**Civil Engineer**  
**Stormwater Best Management Practice (permanent) Certification Letter**

RE: **Redtail Ranch Filing No. 1**

RETAIL RANCH FILING NO. 1  
DRAINAGE IMPROVEMENT PLANS  
EXTENDED DETENTION BASIN NO. 1  
POND PLAN AND DETAILS

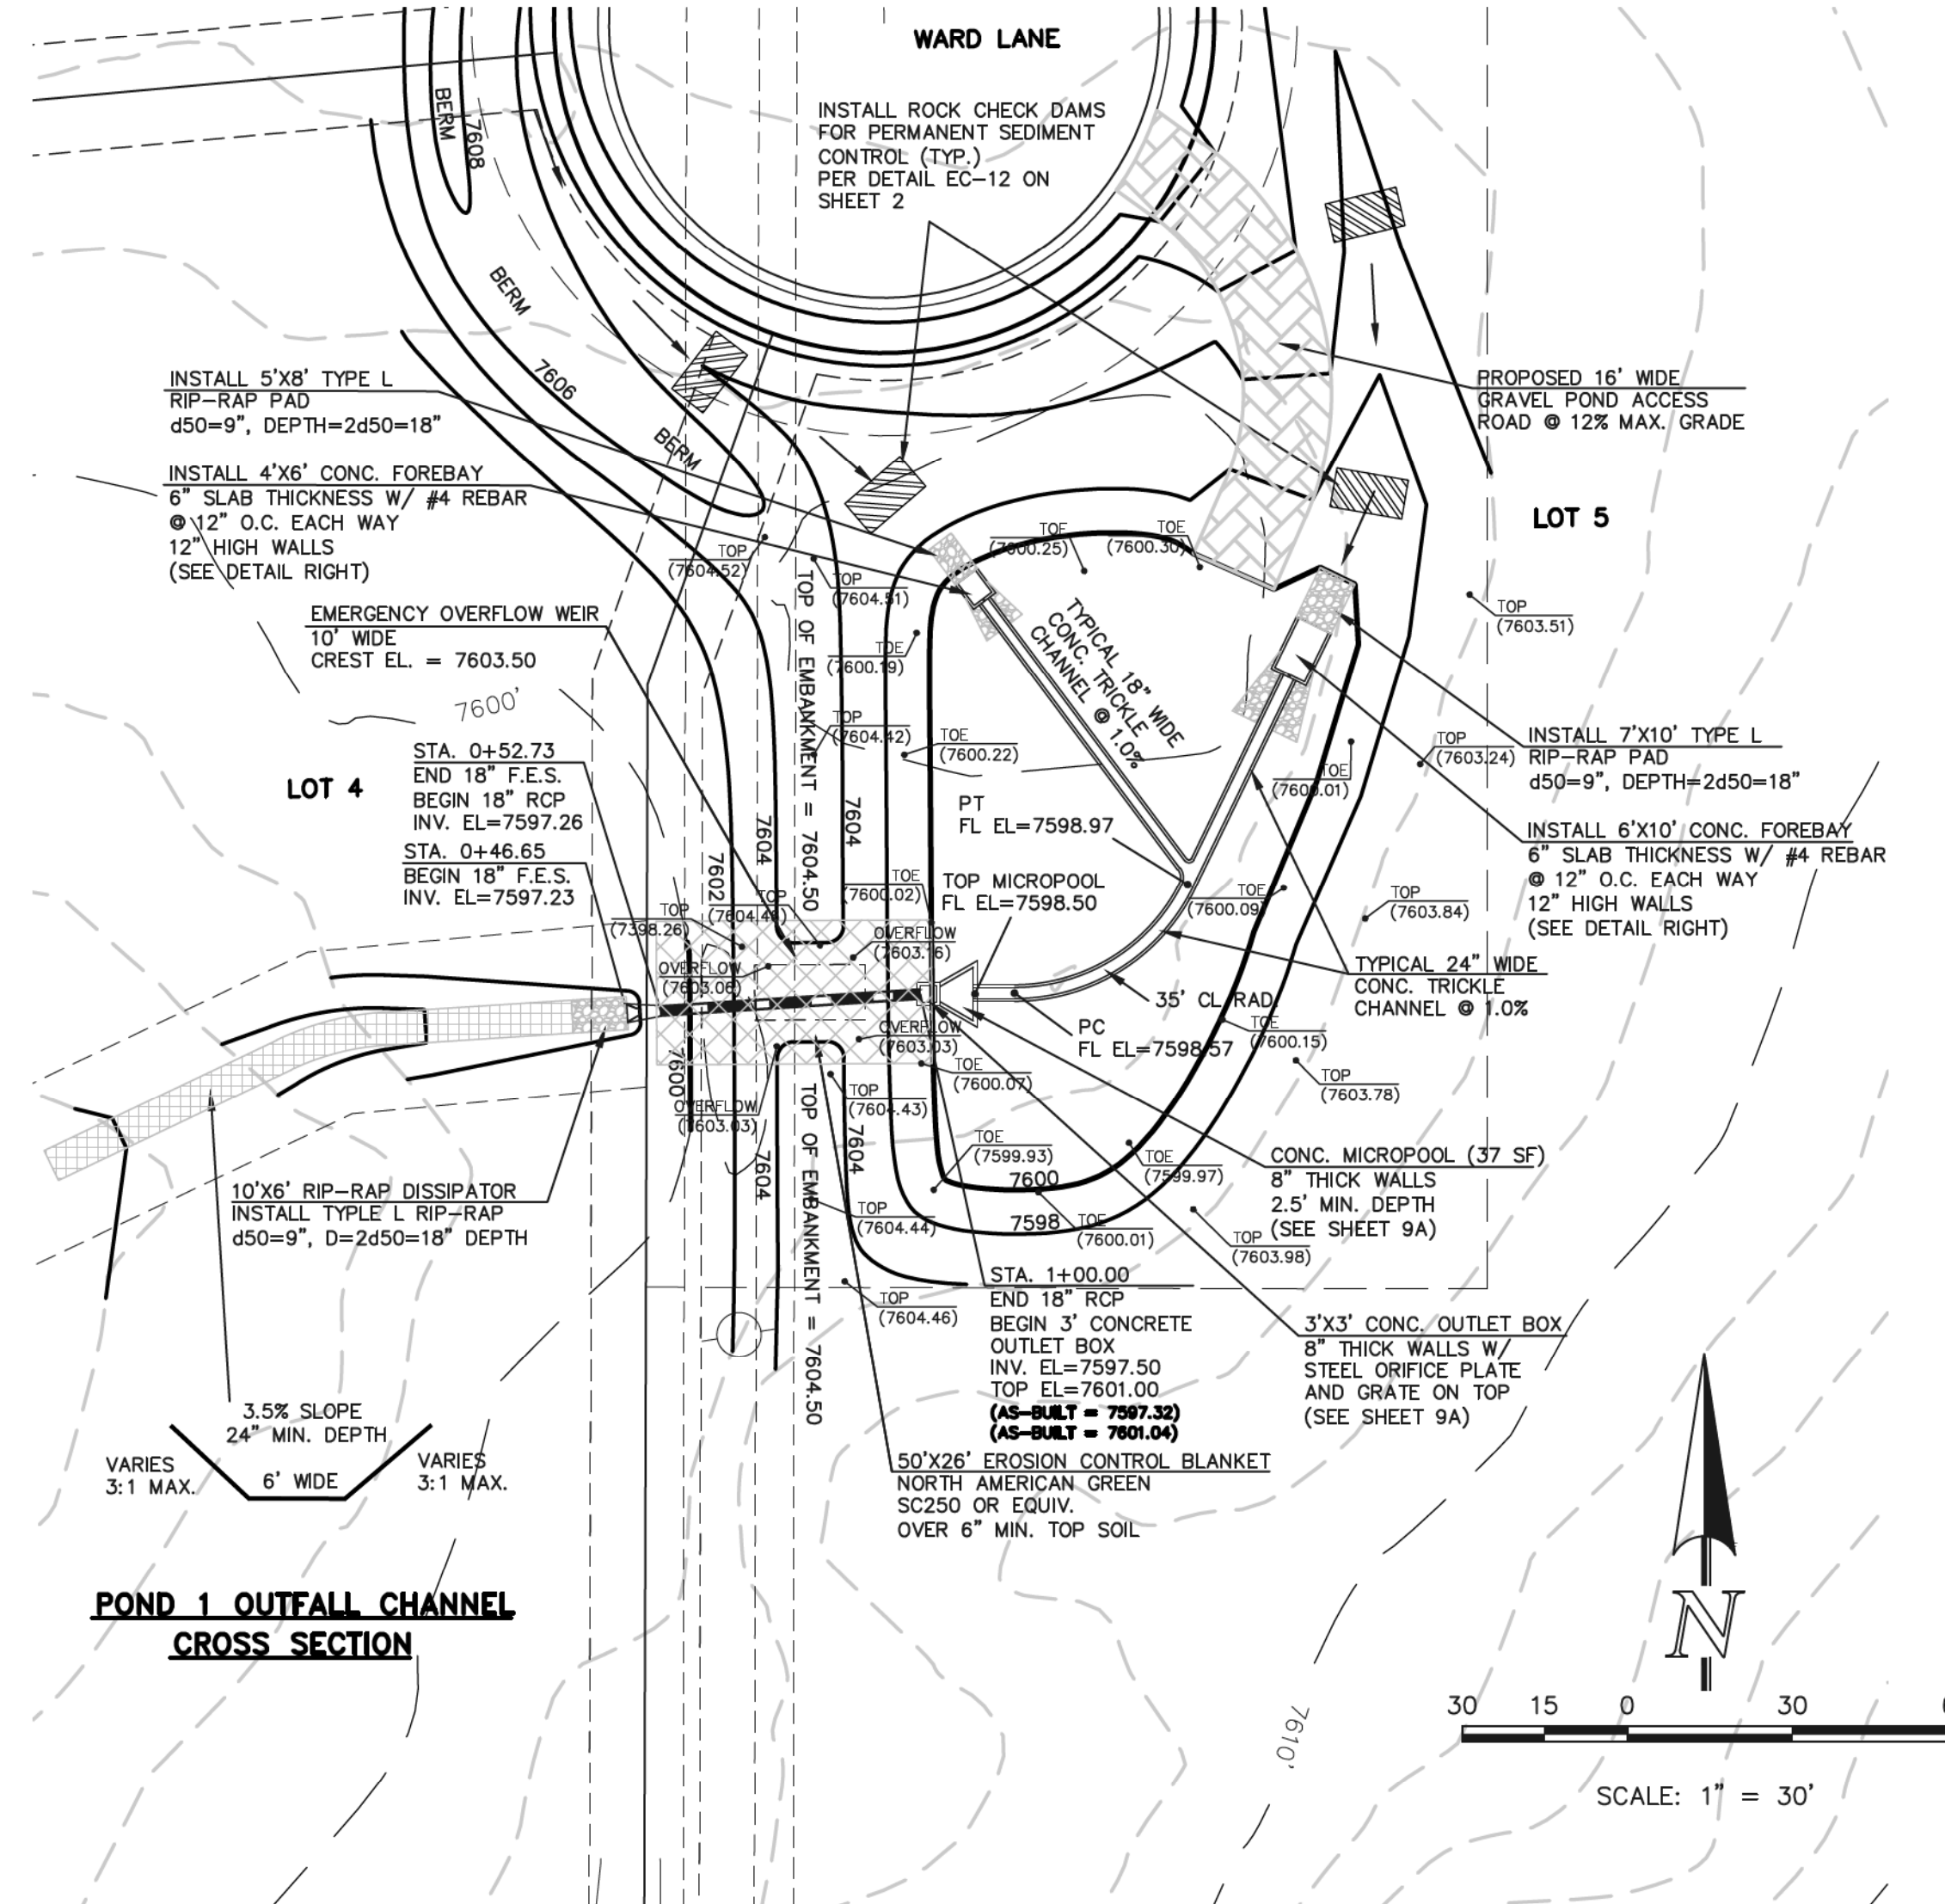
Revise Cert Letters per ECM Chapter 5.10.6.B:

*Engineering Record Drawings shall be accompanied by a certification letter from the Engineer of Record which shall state that the site and adjacent properties (as affected by work performed under the County permit) are stable with respect to settlement and subsidence, sloughing of cut and fill slopes, revegetation or other ground cover, and that the improvements (public improvements, common development improvements, site grading and paving) meet or exceed the minimum design requirements.*

*For sites including detention and/or water quality facilities, the certification letter shall include a statement that the facilities provide the required storage volume and will meet the required release rates, as documented by an attached UDFCD design form submitted with the original application, the stage areas, elevations and outlet dimensions. If the detention/WQCV facility cannot be modeled with UDFCD spreadsheets due to a large contributing area, other verified stage/storage/discharge tables for the applicable design storms shall be provided with the certification letter.*

**EXTENDED DETENTION BASIN 1**

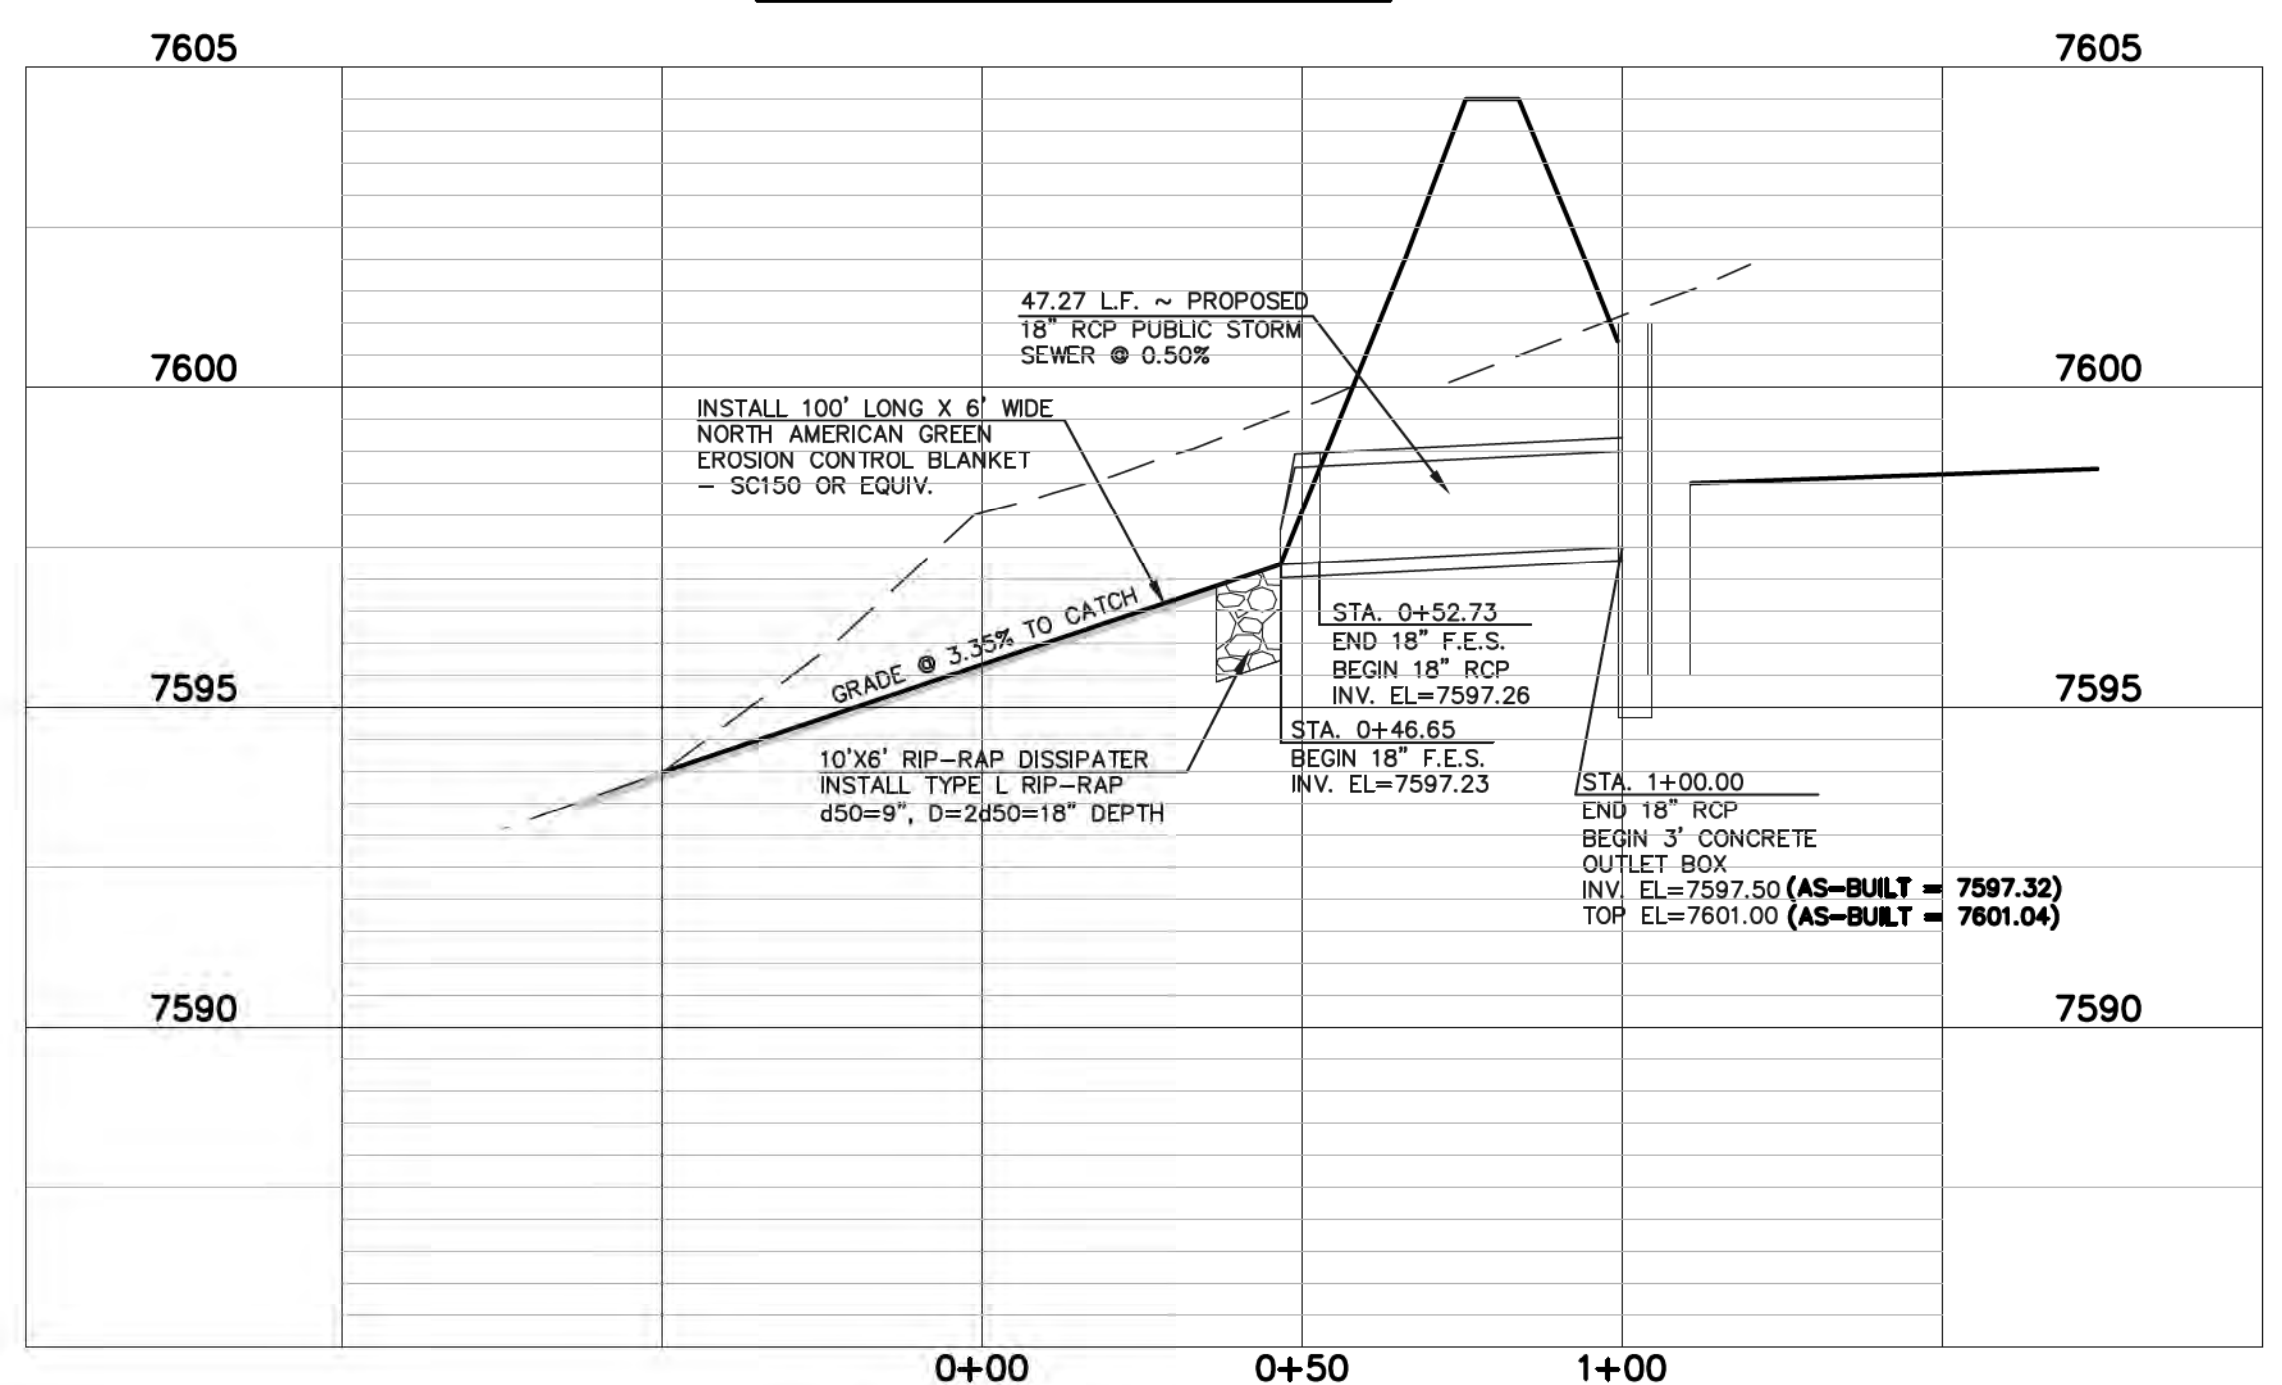
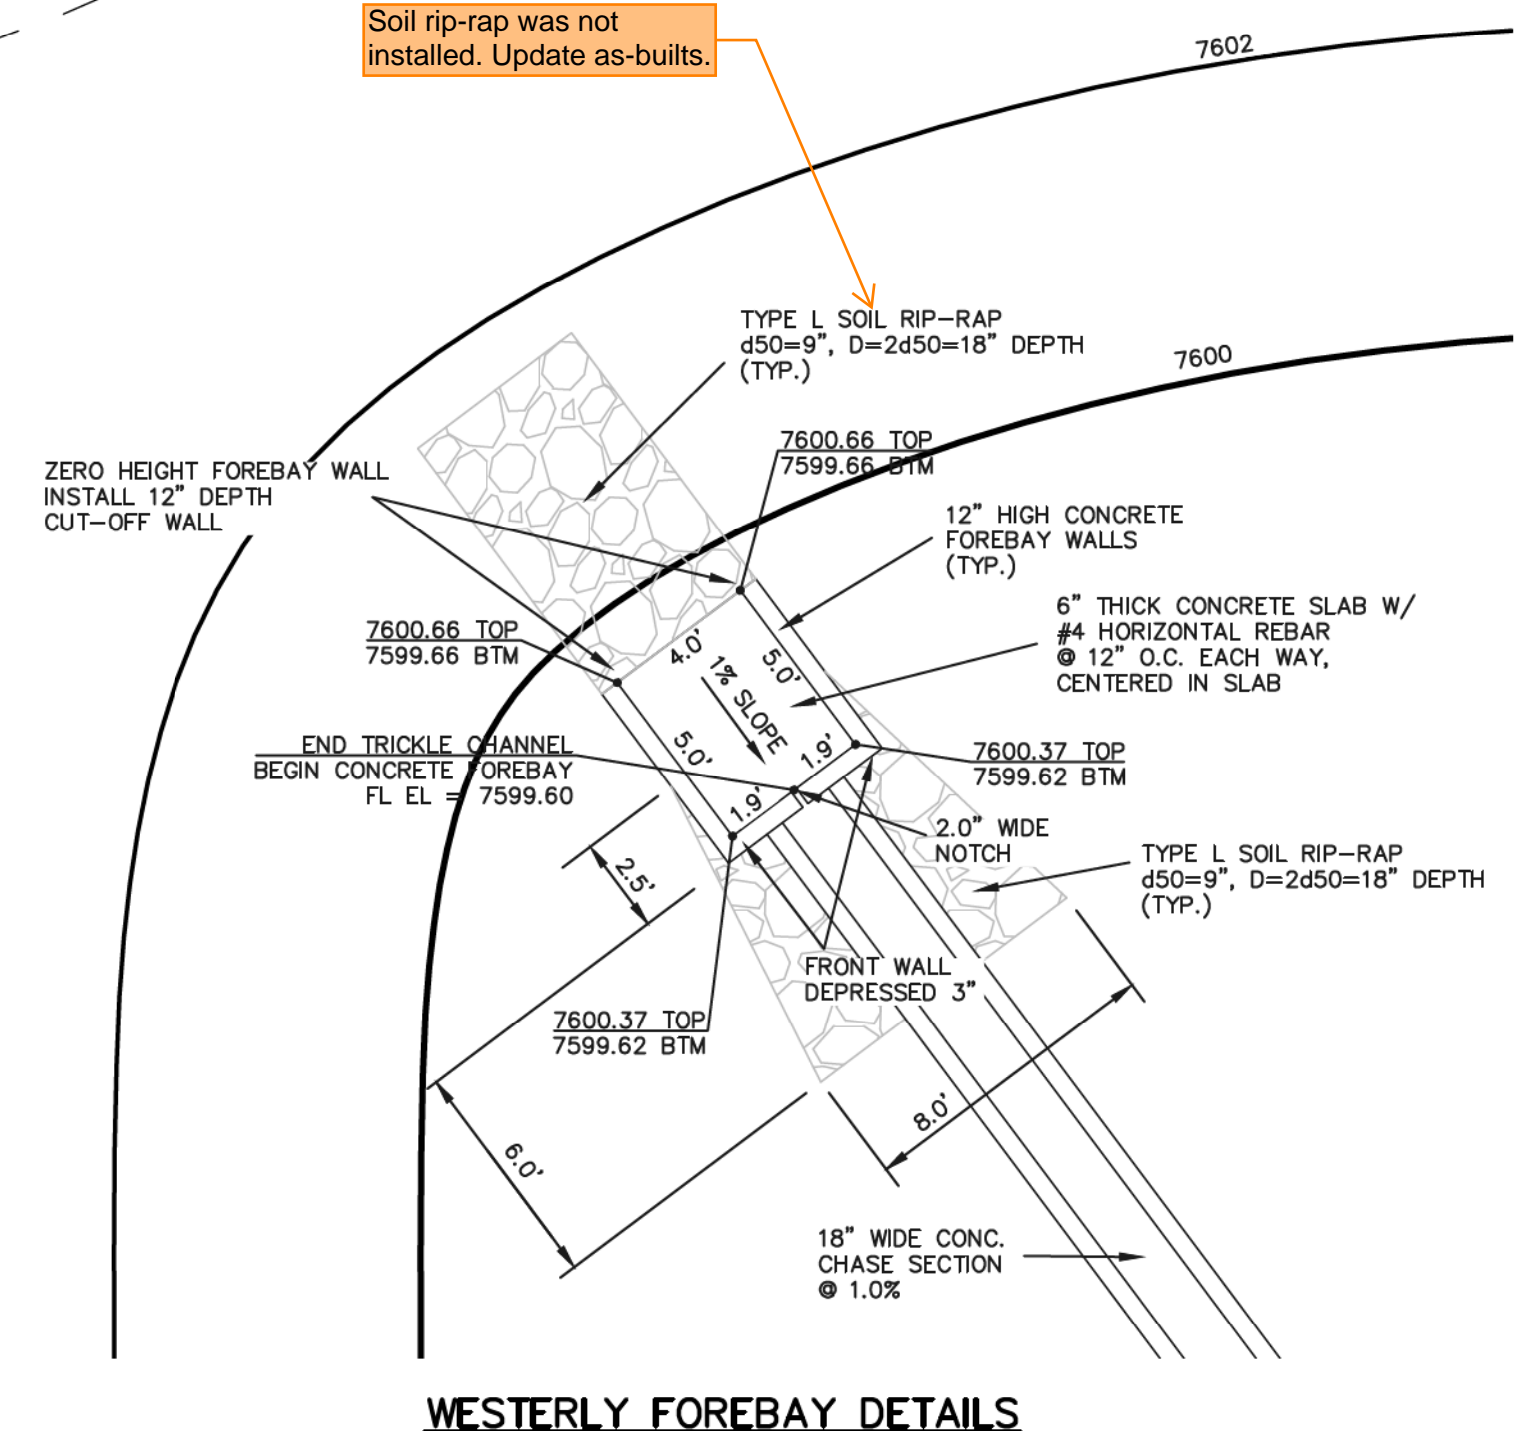
From field observations, Pond 1 does not appear to be draining within in the time that it was designed to. It did not appear to be a maintenance issue like clogging or a install issue like undersized orifice.

Please call Mikayla at 719-339-5053 to discuss more specifics if you have questions.
